IFB Number: IFB 23-007/KJS
IFB Title: Directional Boring at East Clubb Detention Project
IFB Due 2:00 PM, CST, May 18, 2023
Addendum No.: 1
Issued (Date): May 15, 2023

East Club Road Detention Basin

East Club Road Detention Basin	DATE
Siphon Layout	
Walton R. Wilson P.E.

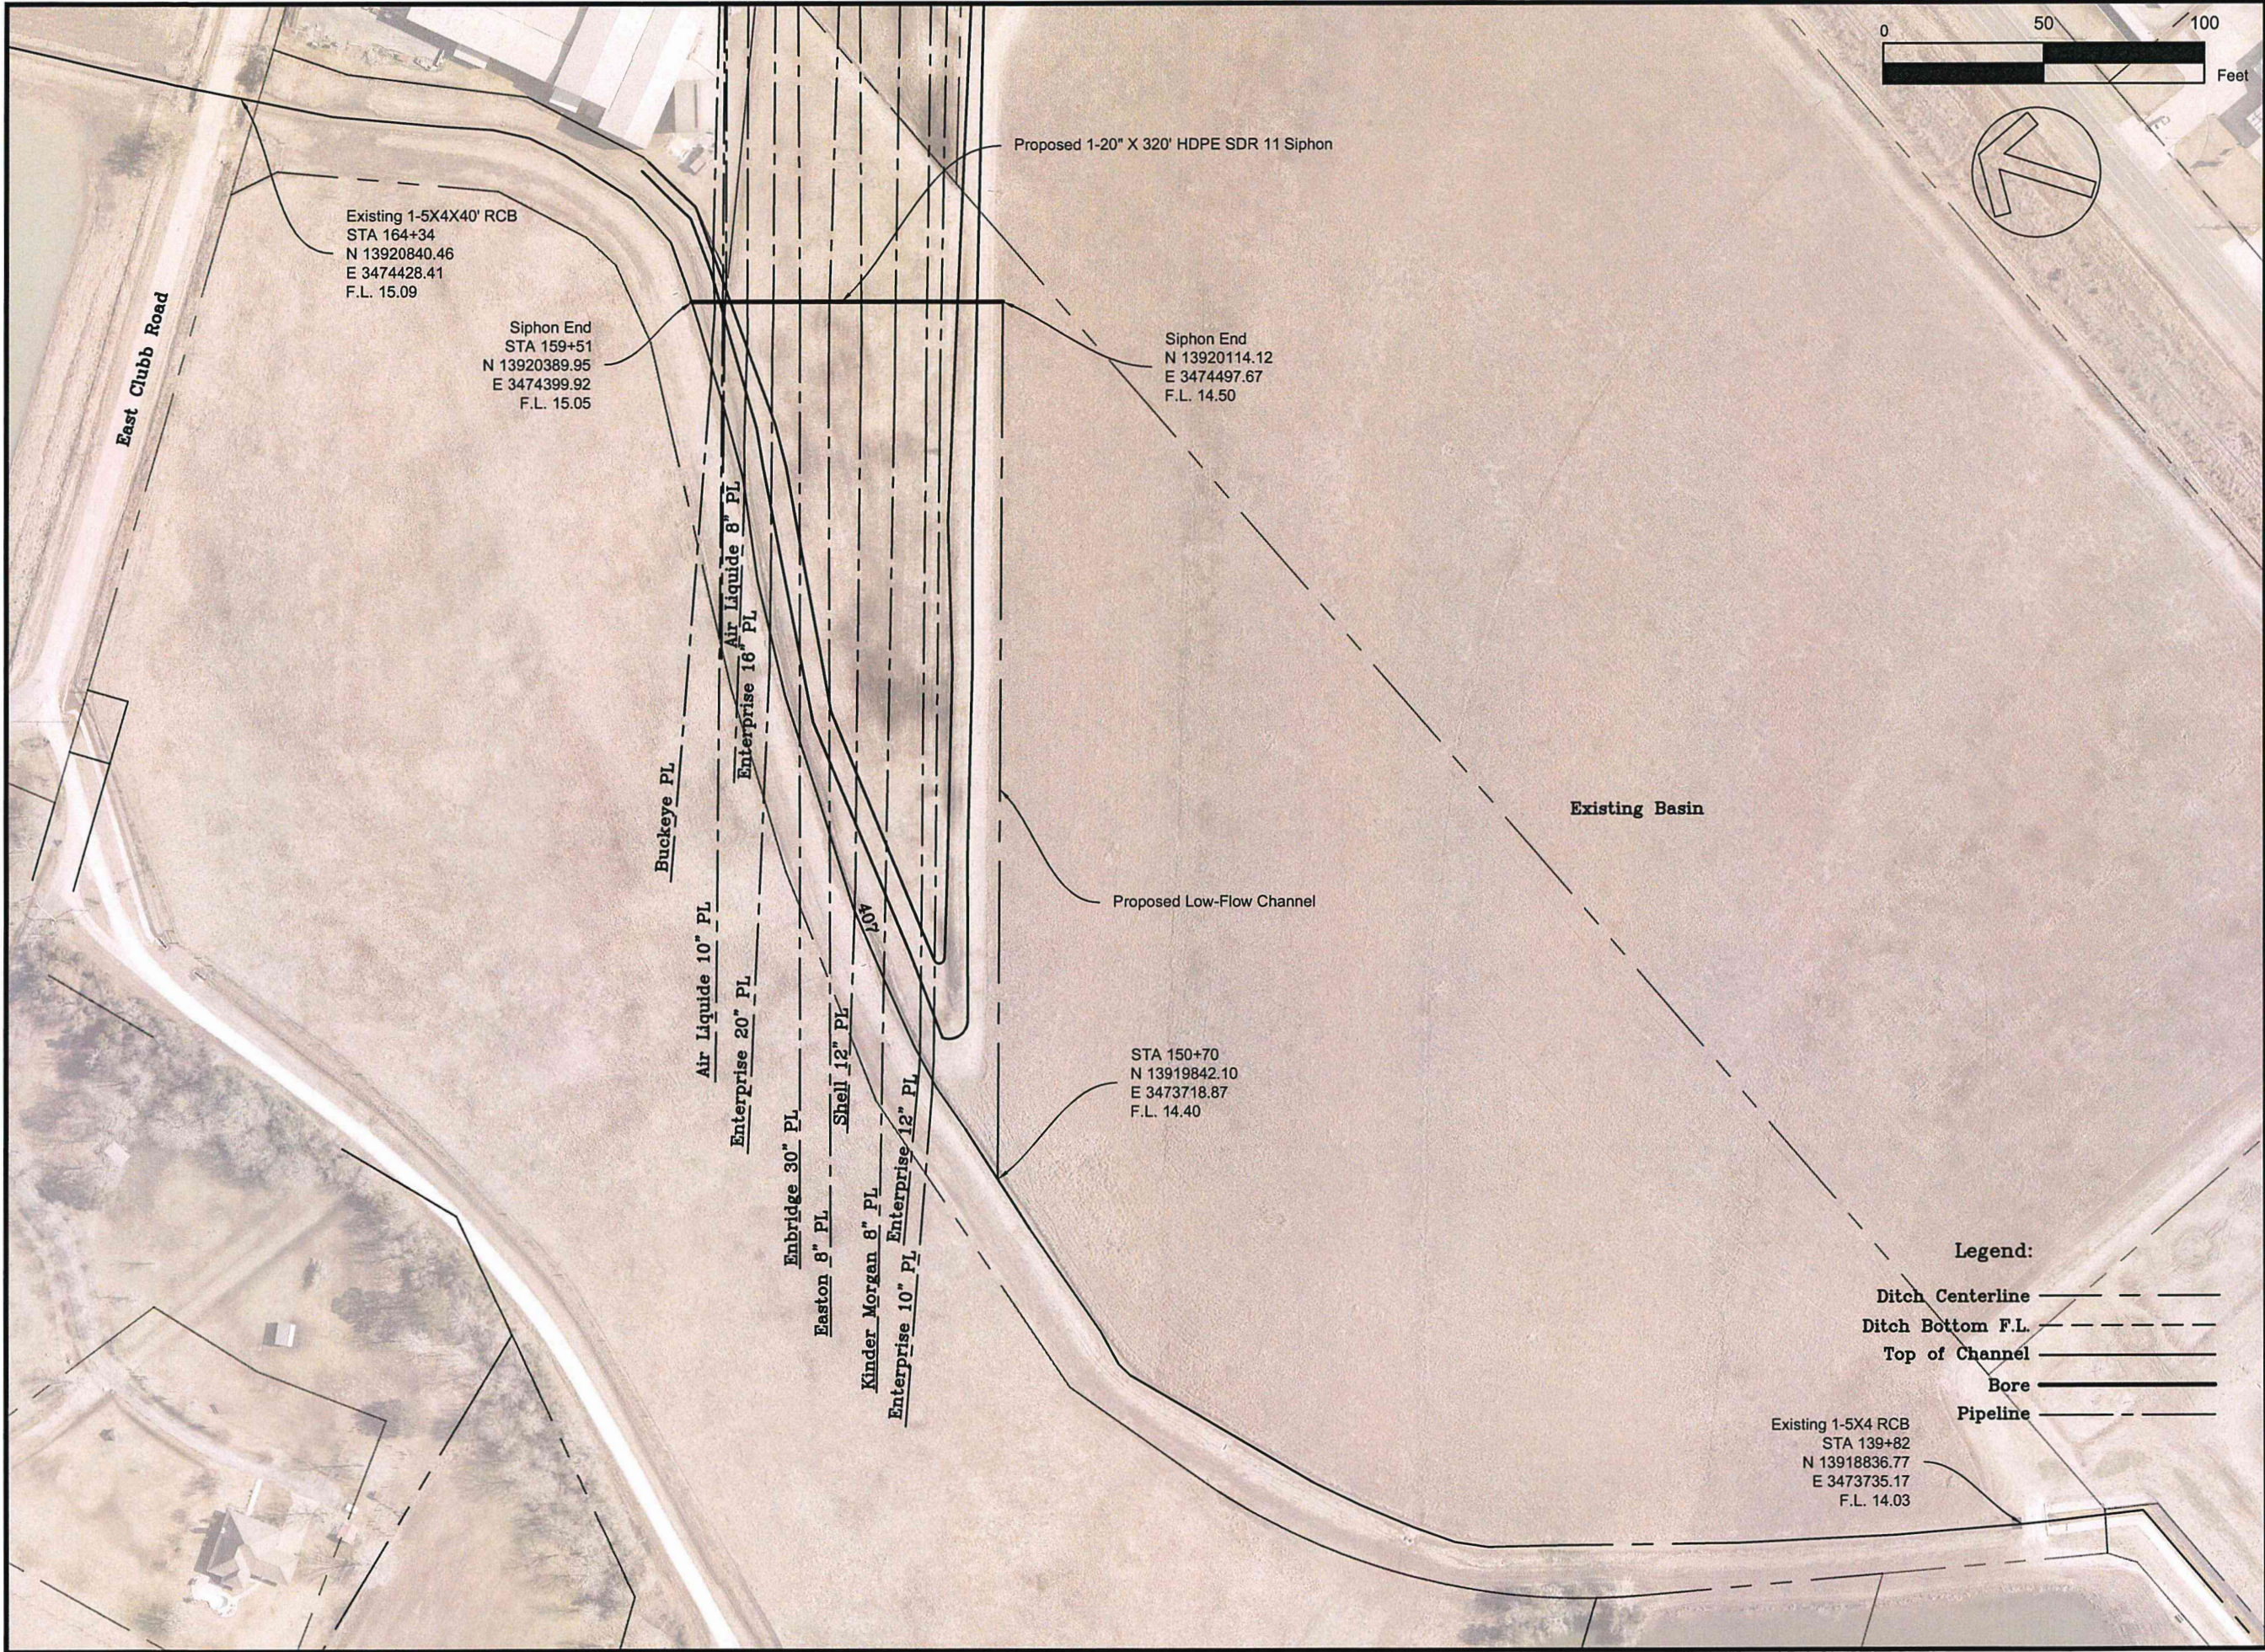
Question: Was the length measured straight or at a curve?

Answer: The length of the siphon did not change after relocation was modified, it is 320 feet. The length of the siphon is measured along the actual siphon. Attached are the ammended drawings. All addendums will be posted on the DD6 website: <https://dd6.org/departments/purchasing/notices-for-bid/>
